Proposal for Supplement 3 to the 03 Series of Amendments UN Regulation No. 100 (Electric power-train vehicles)

Submitted by the experts from the International Association of the Body and Trailer Building Industry (CLCCR)

Figure 3
Marking of vehicles of category O: Use of wheel chocks

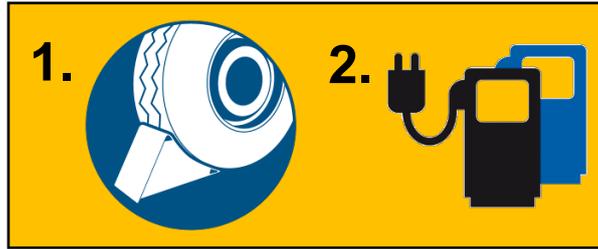
In case of vehicles of category O the vehicle shall provide an audible warning if a vehicle movement is detected, and movement shall be impeded by the use of wheel chocks. A visual instruction shall be made visible by a symbol shown in Figure 3 near the vehicle inlet."

In cases the trailer REESS is charged externally the trailer shall provide an audible warning if a trailer movement is detected. Furthermore a instruction to use wheel chocks is to be placed on a label near the trailer inlet.

Figure 1
Generic description of test pulses

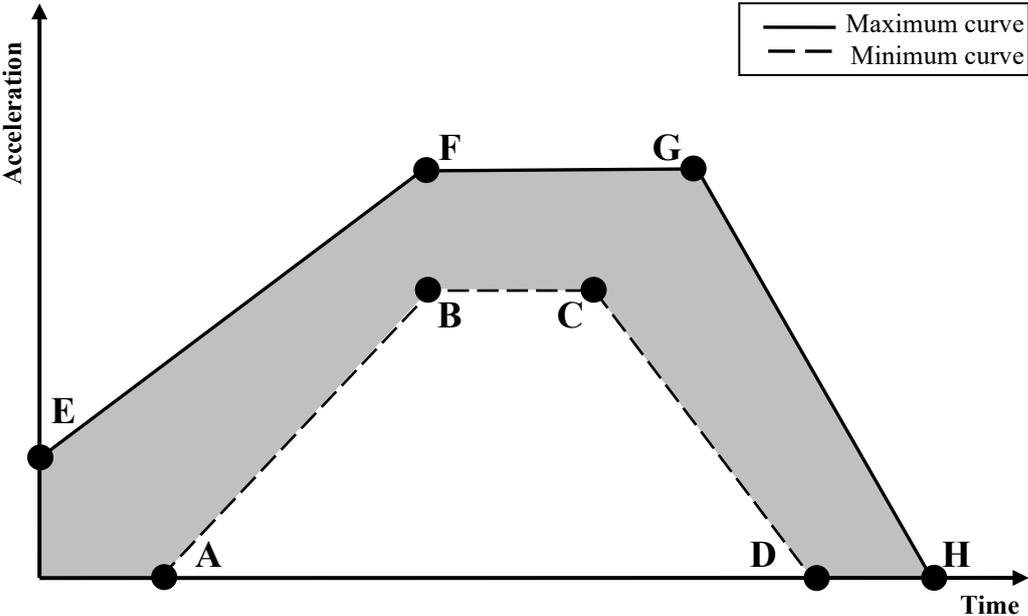
The Tested-Device shall be decelerated or accelerated in compliance with the acceleration corridors which are specified in Tables 1 to 3. The manufacturer shall decide whether the tests shall be conducted in either the positive or negative direction or both.

The test pulse shall be within the minimum and maximum value as specified in Tables 1 to 3. A higher shock level and /or longer duration as described in the maximum value in Tables 1 to 3 can be applied to the Tested-Device if recommended by the manufacturer.

The resistance against mechanical shock are focusing on pulses of crash tests or similar performance tests of vehicles of category N1, N2, N3, M1, M2 and M3. Trailers are normally not in the scope of crash test regulations due to missing passengers. Therefore it is recommended to define basic performance pulses for trailers in relation to the category of the trailer. REESS on O1/O2 may be tested with the pulse as defined for N3. REESS for O3/O4 may be tested with a pulse related to requirements from the ADR („Accord européen relatif au transport international des marchandises Dangereuses par Route" – Transport of dangerous goods).

Table 4 for O₃ and O₄ vehicles:

<i>Point</i>	<i>Time (ms)</i>	<i>Acceleration (g)</i>	
		<i>Longitudinal</i>	<i>Transverse</i>
A	20	0	0
B	50	1	1
C	65	1	1
D	100	0	0
E	0	1	1
F	50	2	2

G	80	2	2
H	120	0	0
